July 12, 2024

Version 10

## Front and/or Rear Brakes Squeal when Applied at Low Speeds

Supersedes 19-053, dated May 10, 2024 to revise the information highlighted in **yellow**.

### Front Brake Pad Shims Replacement

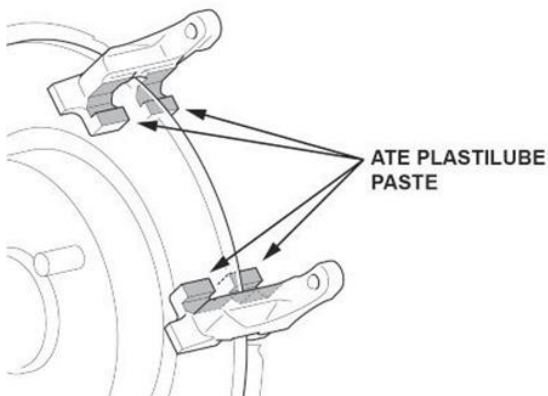
1. Replace **ONLY** the front brake pad shims. Refer to the service information.

NOTE: Make sure to apply the ATE Plastilube paste included with the **front brake pad shim kit**.
